**Compton Community College District
Geotechnical and Soils Investigation Report
For
Campus Public Safety Building**

- 1. Original Report Prepared by GeoTek, Inc. dated October 24, 2016**
- 2. Supplemental Geotechnical Report and Evaluation regarding over-excavation requirements dated January 16, 2017 prepared by United-Heider Inspection Group**
- 3. DSA form 109 Transfer of Responsibility: Geotechnical Engineer from GeoTek to United-Heider Inspection Group dated January 27, 2016**
- 4. CGS First review letter dated January 30, 2017**
- 5. United-Heider Response to CGS first review letter dated April 5, 2017**
- 6. CGS Second review letter dated May 1, 2017**
- 7. United-Heider Response to CGS second review letter dated June 2, 2017**
- 8. CGS Third review letter and approval dated June 14, 2017**

Subject: Response to CGS January 30, 2017 Review Letter
Compton Community College – Public Safety Building
1111 East Artesia Boulevard, Compton, California 90221
United-Heider Project# 10-17036PW

Compton Center - Public Safety Building 1111 E. Artesia Blvd, Compton, California	United-Heider # 10-17036-PW	May 2017
	Dam Inundation Map	Figure 7

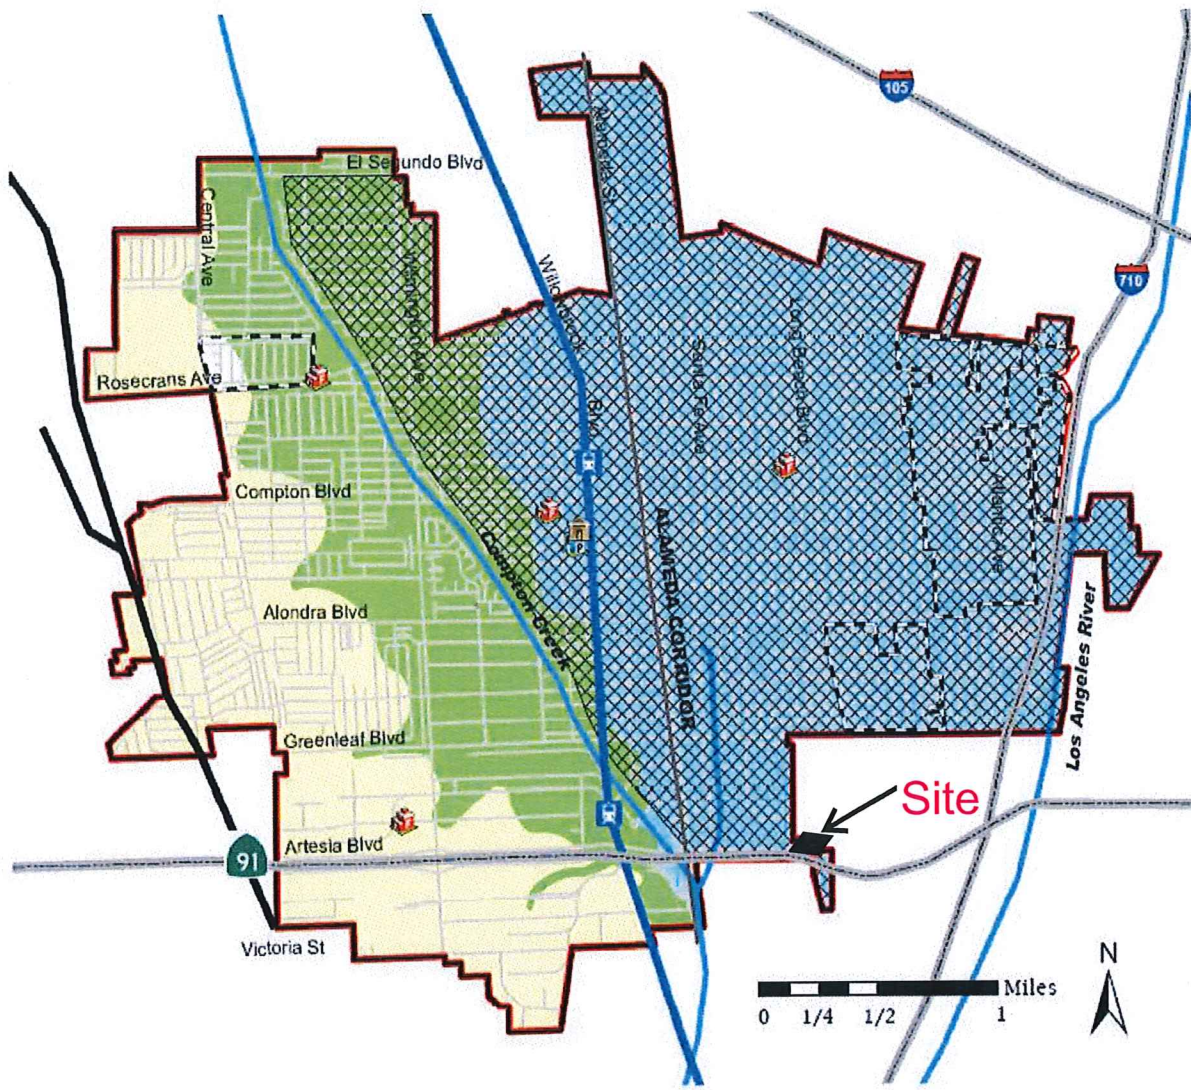
Comment, Note 48, #31-C:

Dam Inundation: As suggested on second review comments, we re-evaluated the project site for location within a potential dam inundation zone. A review of the "City of Compton (City) Safety Element Draft Compton General Plan 2030" indicates that although the site is technically not within the City limits, the Compton CC campus adjoins and is located directly downstream of a City-identified dam inundation zone, as shown on attached *Figure 7a, Seismic and Flood Hazards Map*.
